CONTRACT CHANGE ORDER NO. 1

AIRPORT: Erie Municipal Airport

LOCATION: Erie, Colorado

AIP NO.: 3-08-0090-023-2024

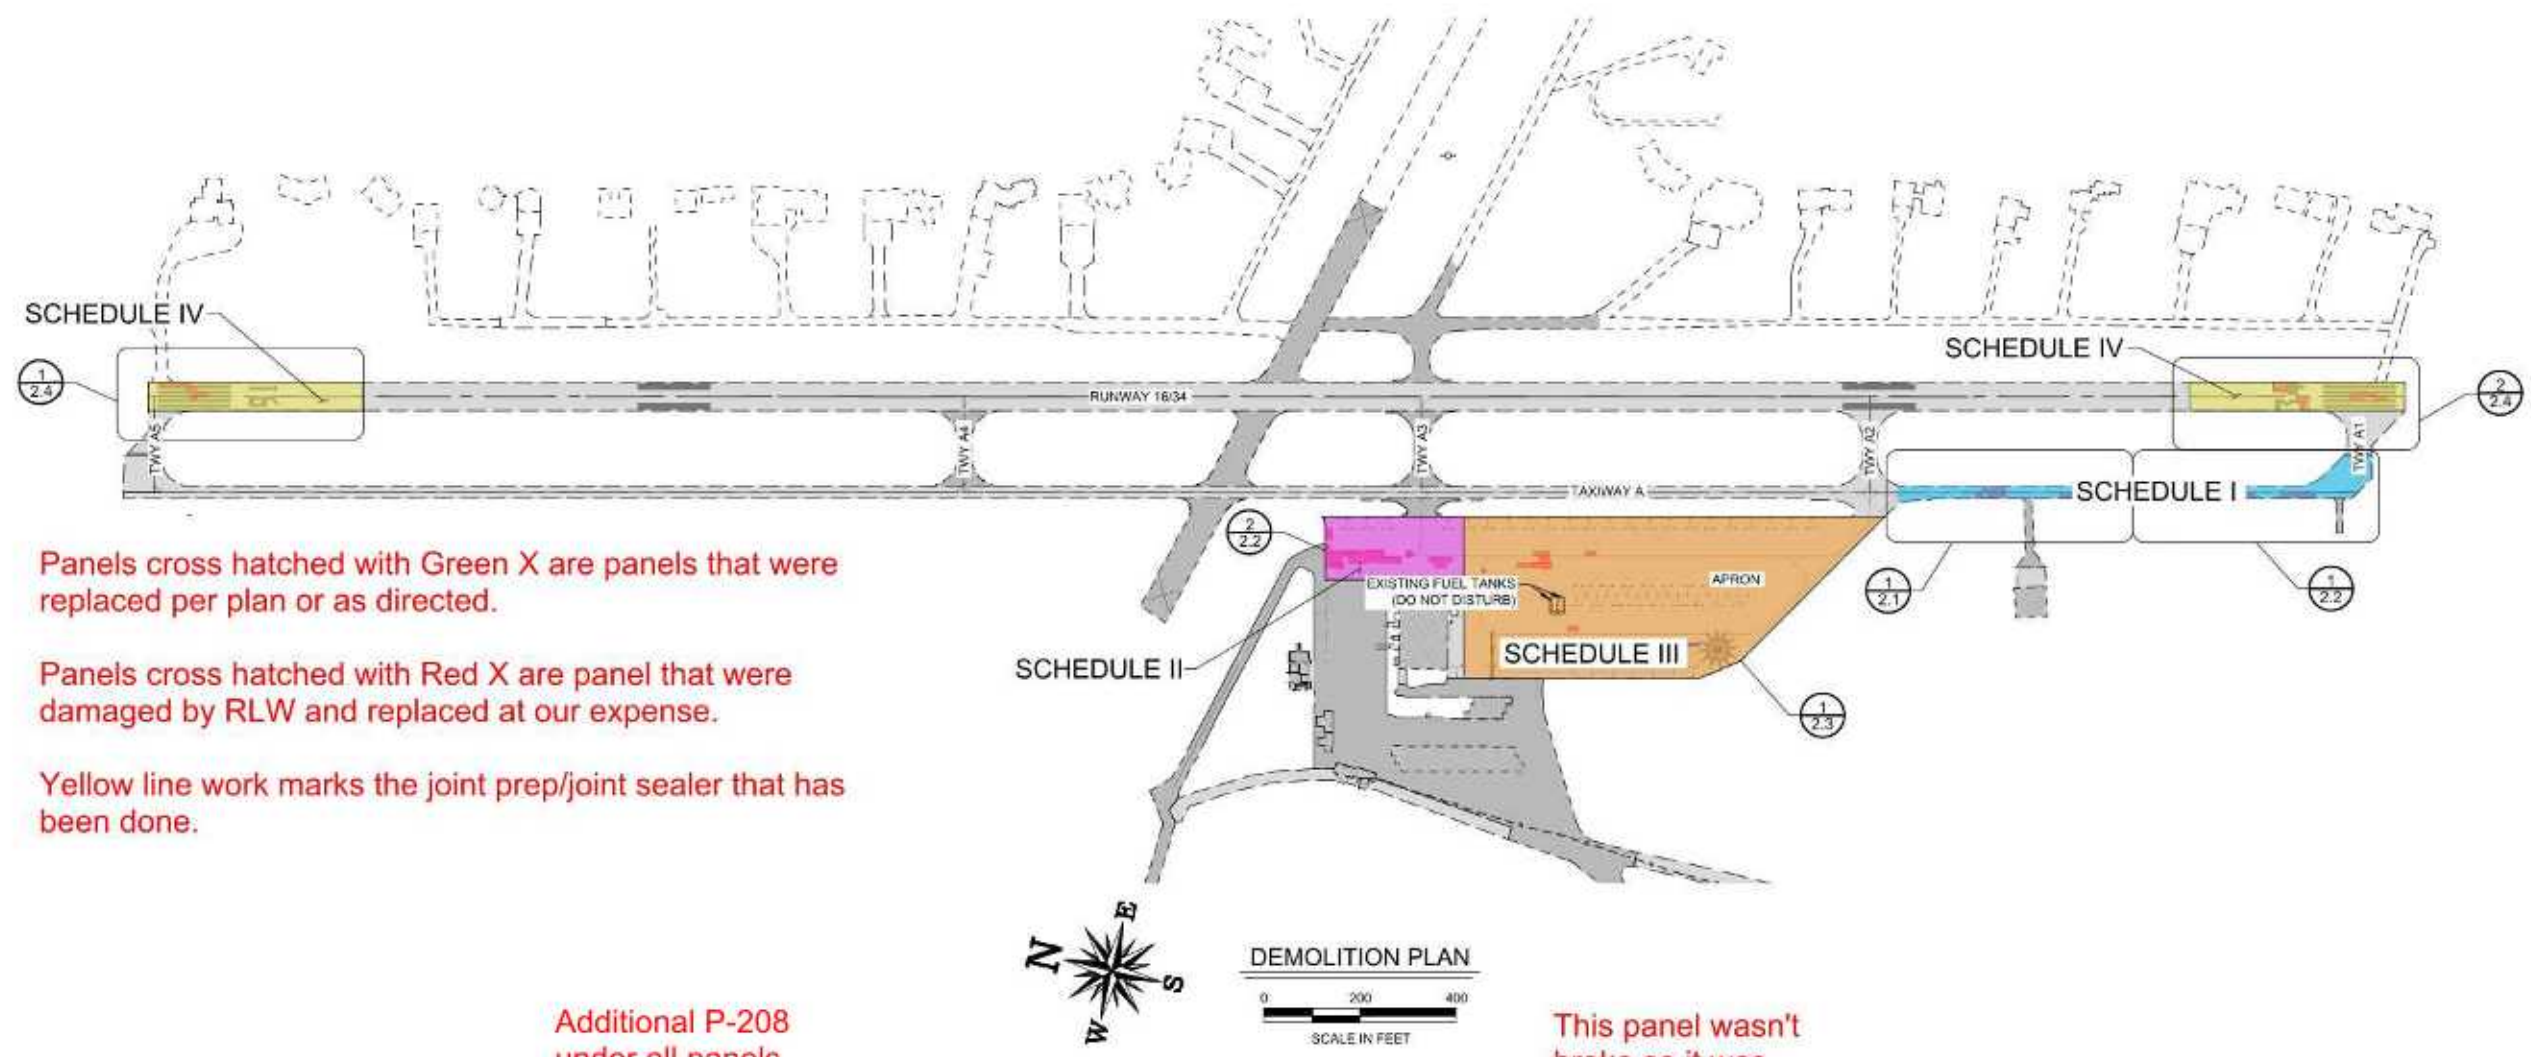
Additional Quantities
 Two additional panels replaced at the Rwy 34 end
 Average Taxiway Panel = 12.5' x 10' = 13.9 SY
 6" of additional P-208

Total Amount of P-208 placed = 67 CY
 P-208 Bid Amount = 10 CY
 Additional P-208 = 56.6 CY x \$812.87 = \$46,008.44
 Total of P-501 placed = 63.5 CY
 P-501 Bid Amount = 60 CY
 Additional P-501 = 3.5 CY x \$1,151.32 = \$4,029.62
 Additional P-620b Temp Marking = 205 SY x \$1.81 = \$371.50

DEMOLITION PLAN

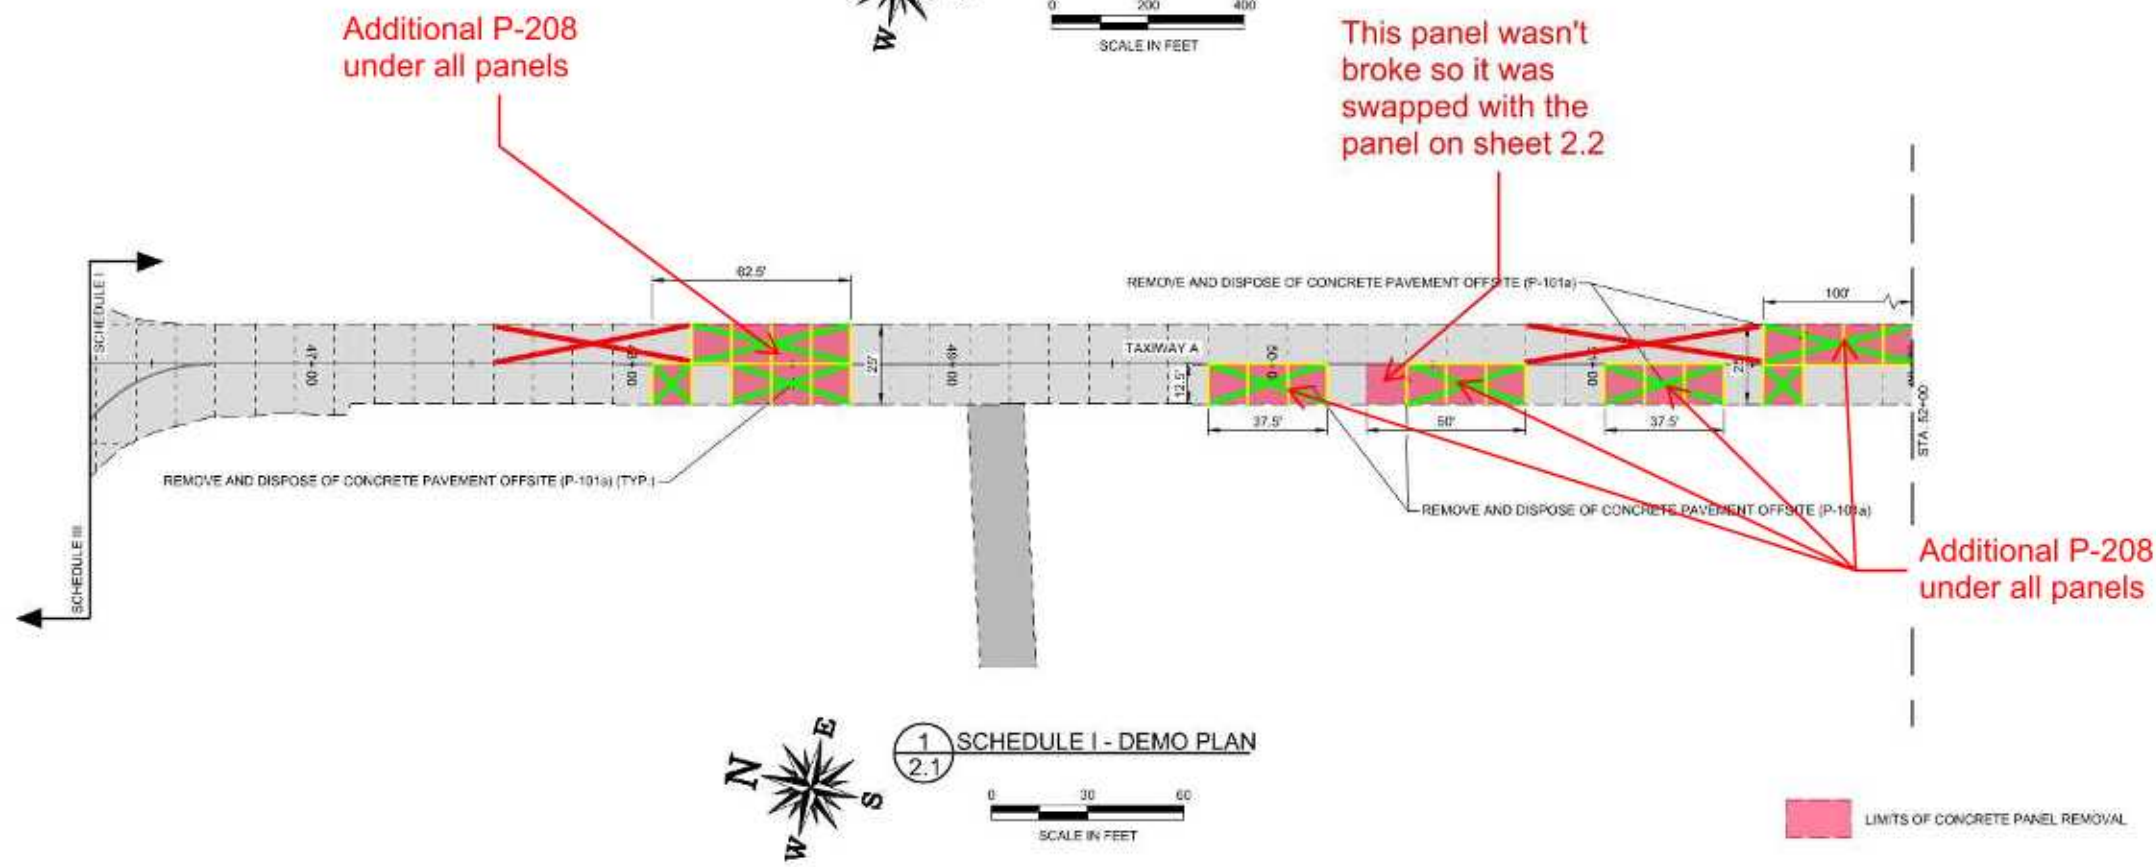
Panels cross hatched with Green X are panels that were replaced per plan or as directed.

Panels cross hatched with Red X are panel that were damaged by RLW and replaced at our expense.

Yellow line work marks the joint prep/joint sealer that has been done.

DEMOLITION PLAN

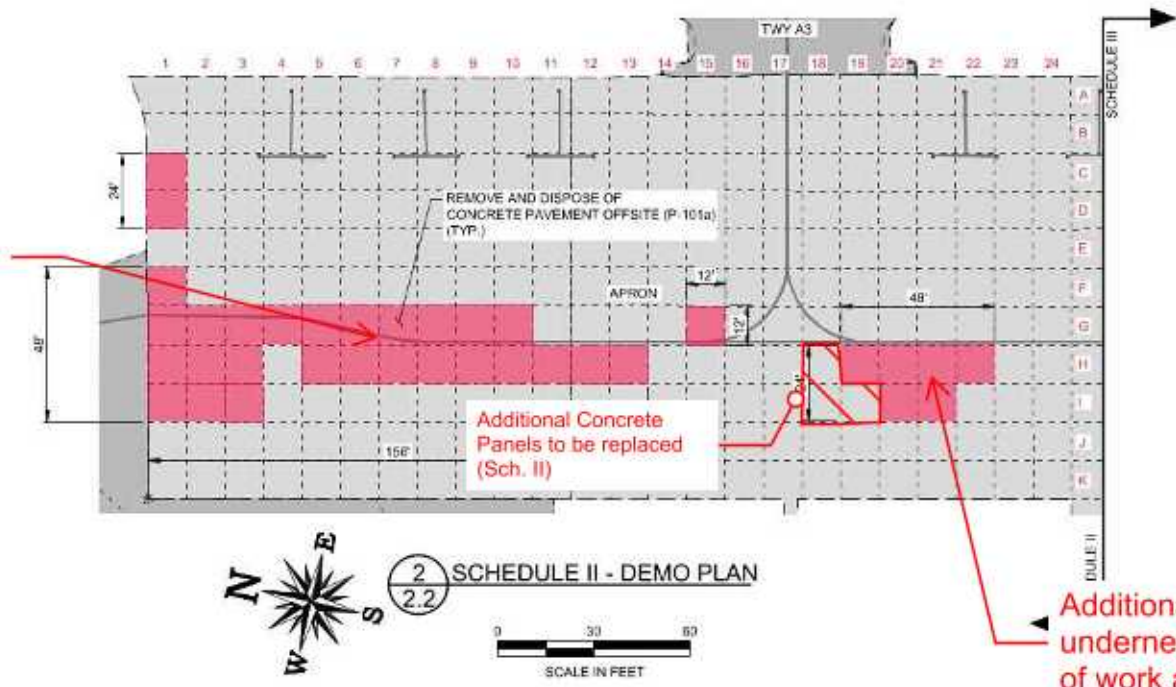
Additional P-208 underneath portions of work area

Additional P-208 underneath portions of work area
